Explosive Safety Board reports to LMD – April & June 2013

R6 Response to Explo Open Burn/Open Detonation Comments
September 22, 2014

<u>Comments on Feb 13, 2014 Draft 7003 Order for Camp Minden, LA</u>
Comments on the Work Plan requirement to include on-site open burning/open detonation (OB/OD), para 73:
Para 73 says "The M6 Propellant Work Plan shall include an on-site open burning/open detonation remedy."
Because alternatives to open burning are available, we should not require, or even encourage, OB in this case. The RCRA and Superfund experiences, and DOD research, show that open burning/open detonation (OB/OD) is a relatively uncontrolled, dirty, polluting technology that should therefore be reserved for situations when there are no practical alternatives or for time-critical explosives safety emergencies, and with the understanding that there will be an extensive and costly clean-up/remedial action needed at closure, which is especially true in this case when considering the volume to be treated at Camp Minden and the presence of DNT. If, on the other hand, there is a known category D M6 propellant (i.e., a time-critical situation) and the alternatives are not yet as readil

Figure 3 – Proposed Solution

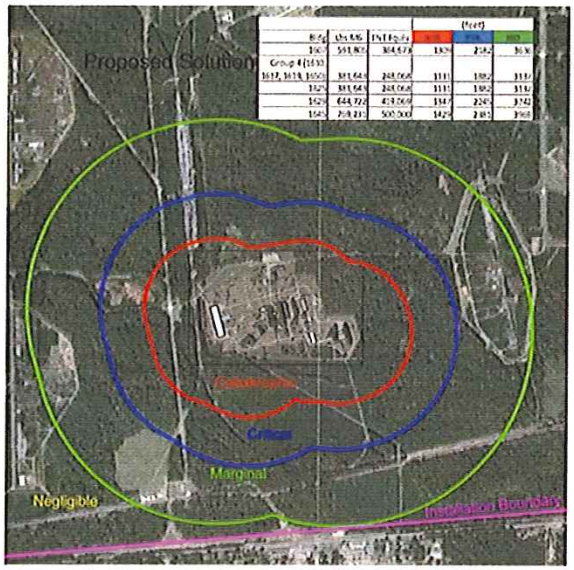
- Reduce the quantity of propellant in building 1607 to 591,805 lbs of M6 propellant. Reduce the amount of M6 propellant in other buildings to the quantities provided in Figure 3.
- Identify the location of all M6 propellant from Lot IND82E-070170, segregate, and dispose of it as soon as possible. The team's review of the DoD lot numbers shipped to Camp Minden revealed that this Lot has been classified with stability category "C."
- Move the LASP's administrative offices outside of the "marginal" arc of Figure 3.

Figure 3 shows the proposed solution. The proposed solution is a "future state" that will meet DoD 6055.09-M's criteria and reduce the threat to the public to a "negligible" level.

- The proposed solution meets DoD 6055.09-M's criteria, with respect to IMD, and provides an acceptable level of protection for the public.

Propellant repackaging operations in building 1607

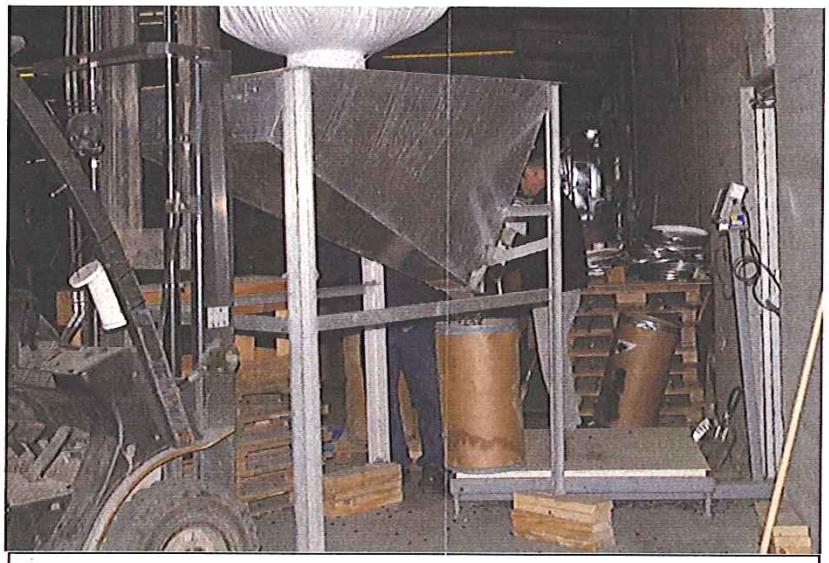
- **Observation**: The amount of propellant in storage in building 1607 creates ESQD violations.

Recommendation: Prohibit Explo from repackaging propellant in building 1607 and move the repackaging operation to another location that complies with DoD 6055.09-M. Limit building 1607's use to storage of M6 propellant.

Tritonal Flaking Belt – Building 1619

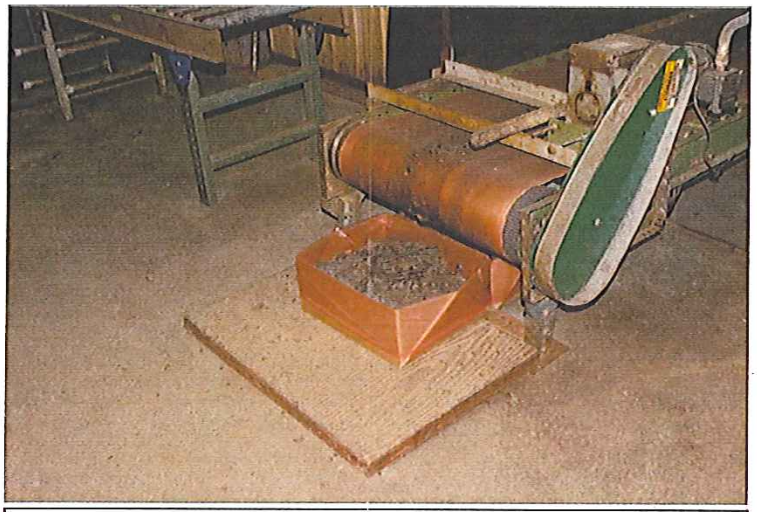
Tritonal scraps located in Building 1619 generated from Tritonal flaking operation

Recommendation: Remove, segregate and store explosives per DoD 6055.09-M's explosives safety compatibility and mixing rules. Comply with DoD 6055.09-M's criteria for storage of waste military munitions. Prohibit the storage of hazardous waste with explosives.

Figure 1

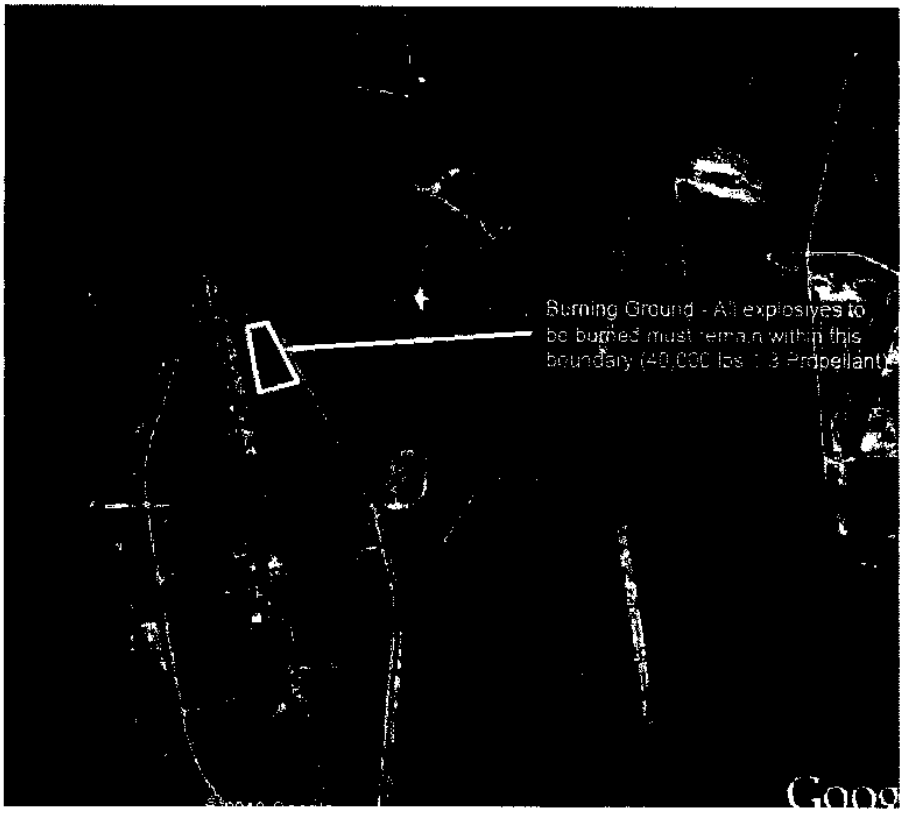
- **Observation:** The TAV team recommends that safety clearance zones near the E-line be established for the potential burning grounds.

Recommendation: Figure 1 (below) depicts the safety clearance zones the TAV team recommends for the burning grounds. With the recommended safety clearance, the burning grounds should be able to accommodate safely 10 burn pans, each one capable of holding up to 4,000 pounds of propellant.
